# ARCHITECT'S SUPPLEMENTAL INSTRUCTIONS

Date Issued:	May 22, 2020
Project:	Intermountain Healthcare <b>Tooele Valley Dialysis Clinic Expansion</b> 2356 North 400 East, Suite #102 Tooele, Utah 84074
Architect's Supplemental Instructions:	<b>ASI #7</b>
To:	Saunders Construction 1113 South 500 West Bountiful, Utah 84010

## Electrical ASI #07

**Project:** Dialysis Clinic Expansion

EP101

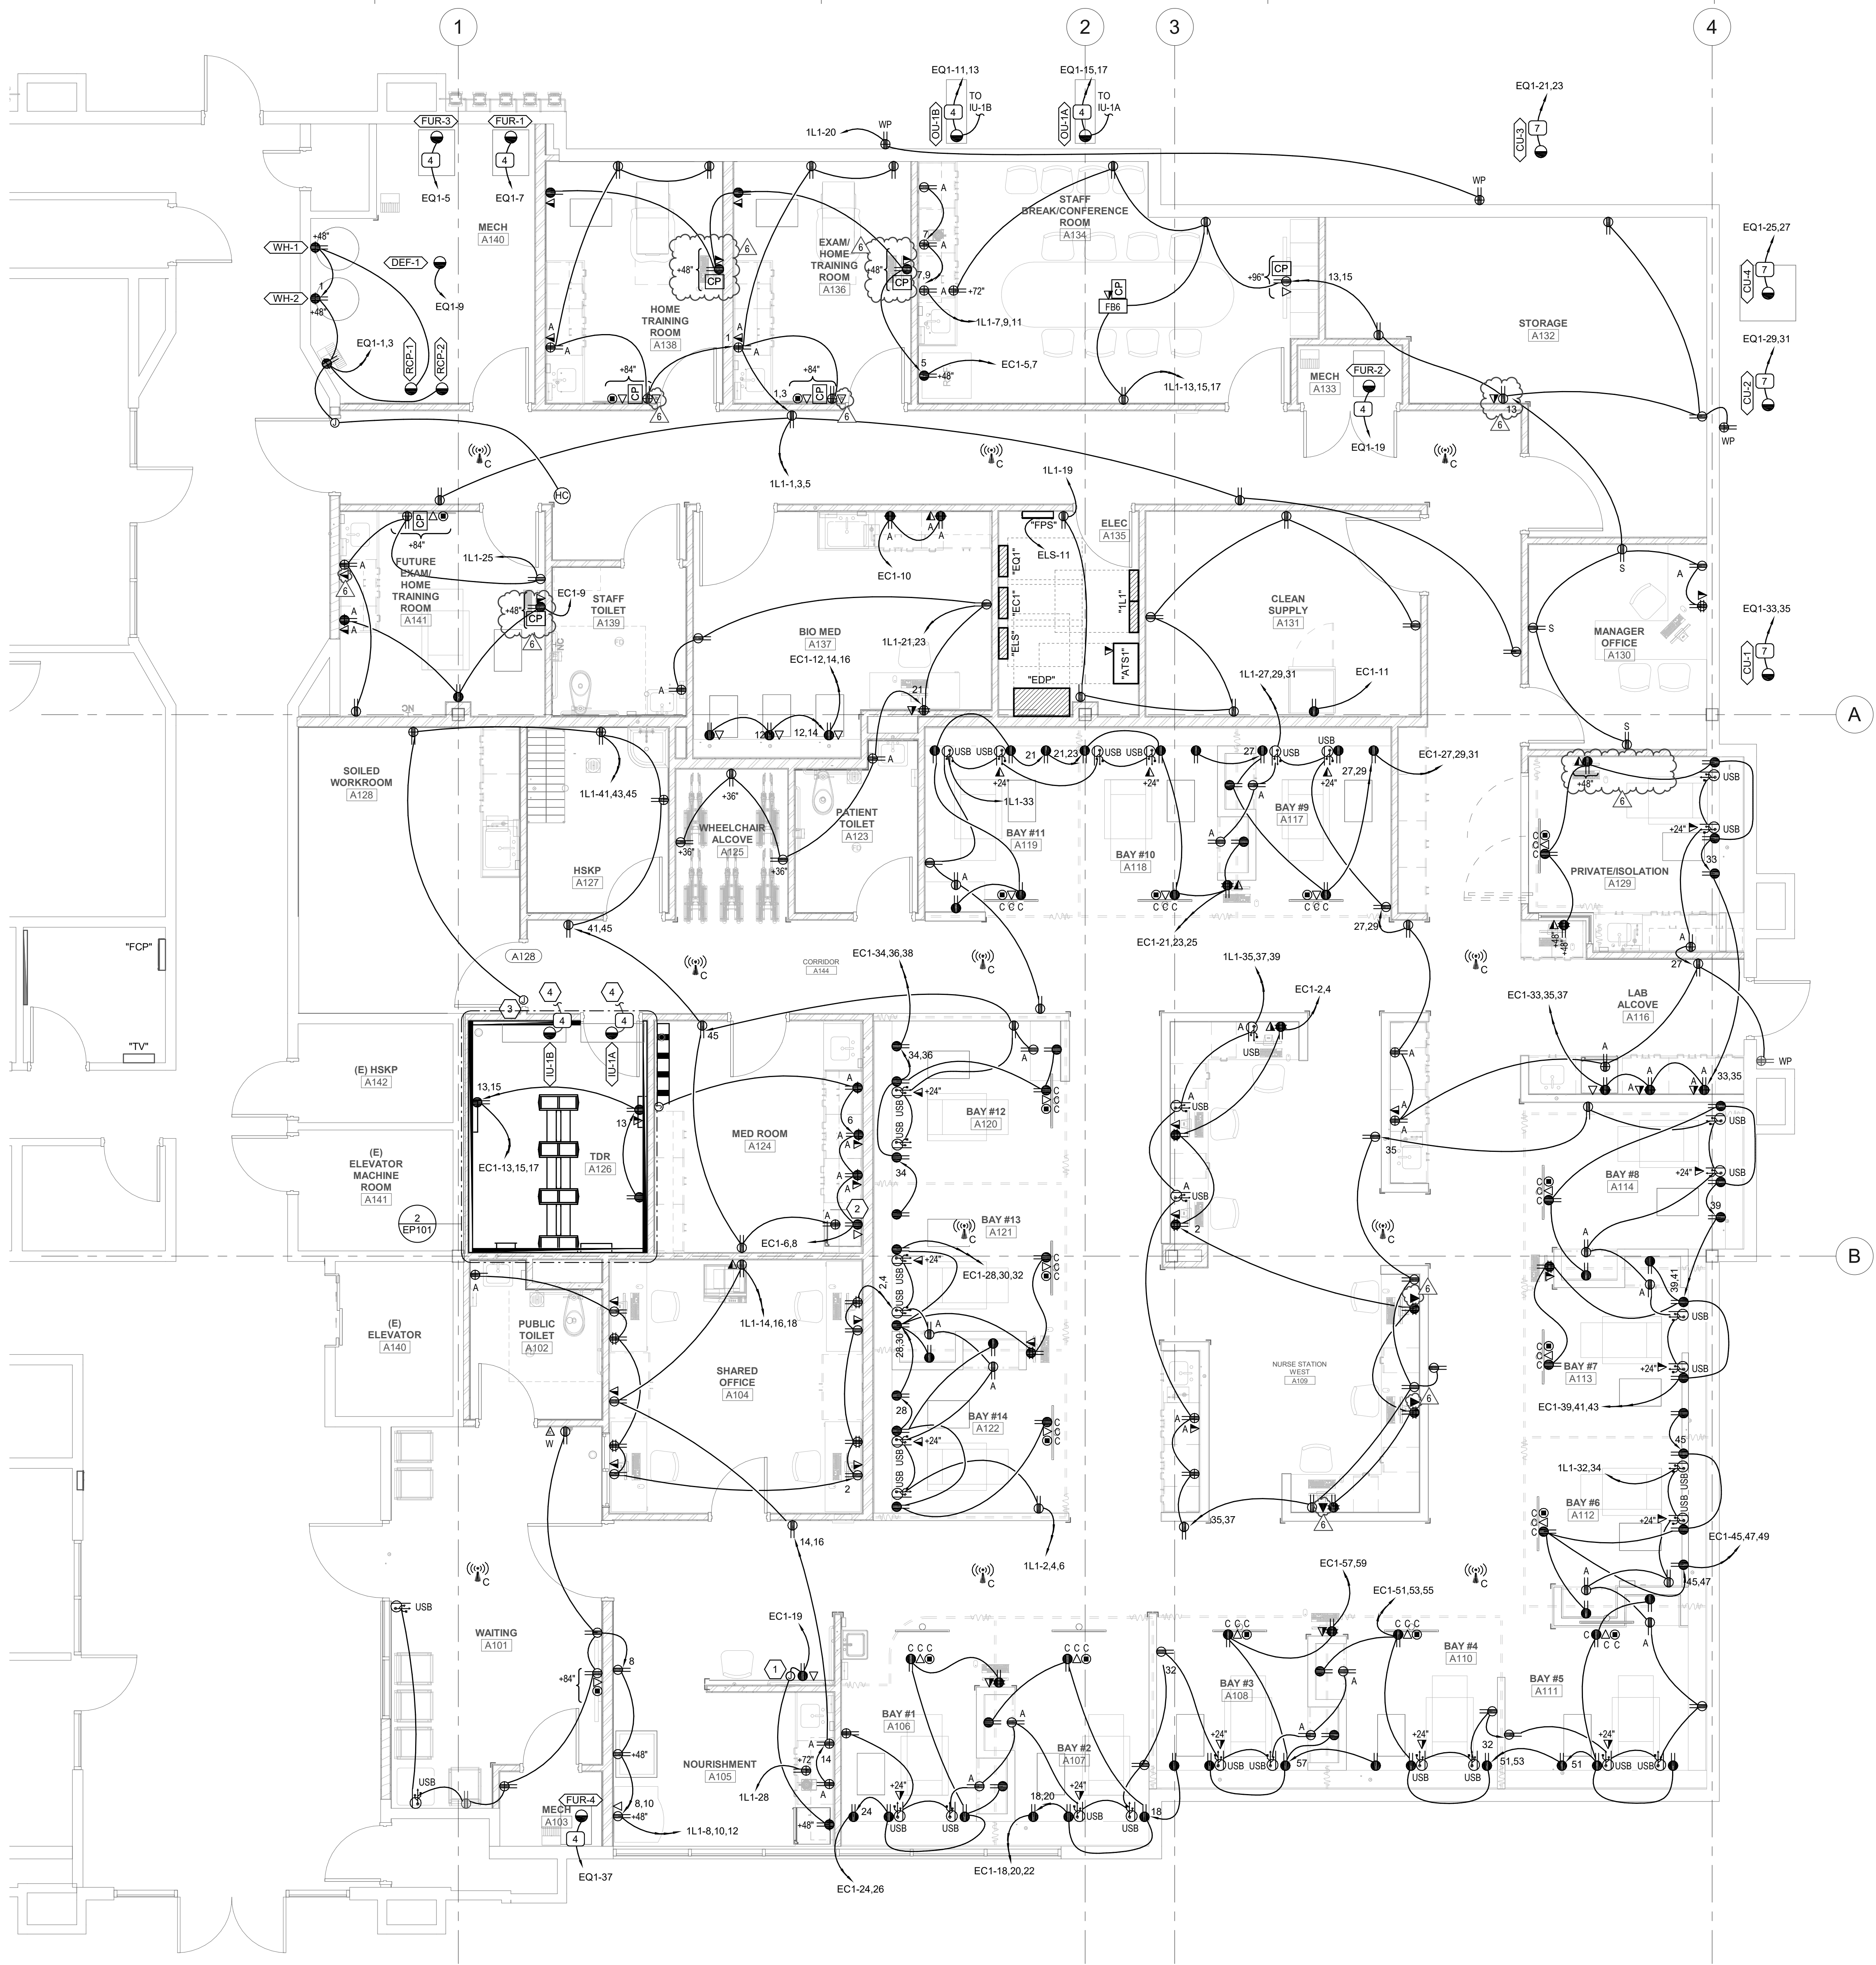
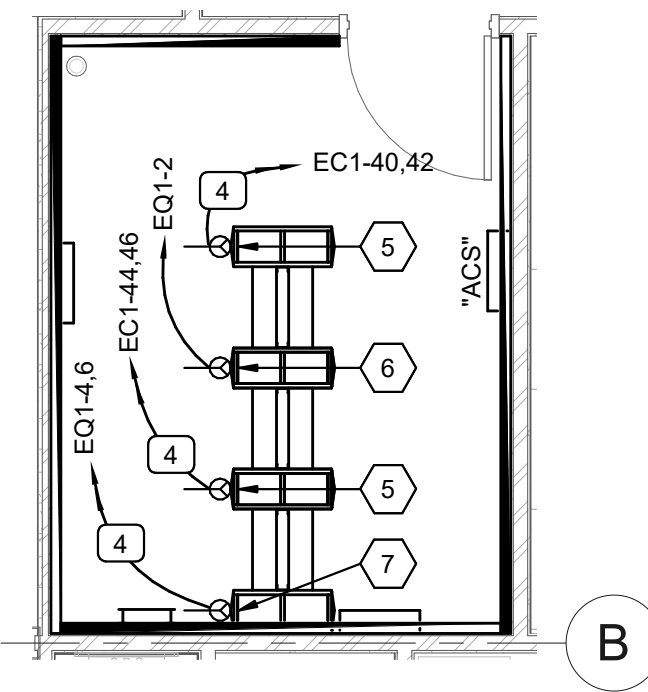
1. Relocated monitor receptacles to 48" AFF in A136, A138, & A141.
2. Added wall phone in A136, A138, & A141.
3. Added a 2-drop data receptacle in A141.
4. Relocated power receptacle and added a 2-drop data receptacle in A132.
5. Power receptacle in A129 was re-circuited/repurposed to provide power for a monitor.
6. Added data for monitor in A129.
7. Three 2-drop data receptacles in A109 were changed to 3-drop data receptacles.
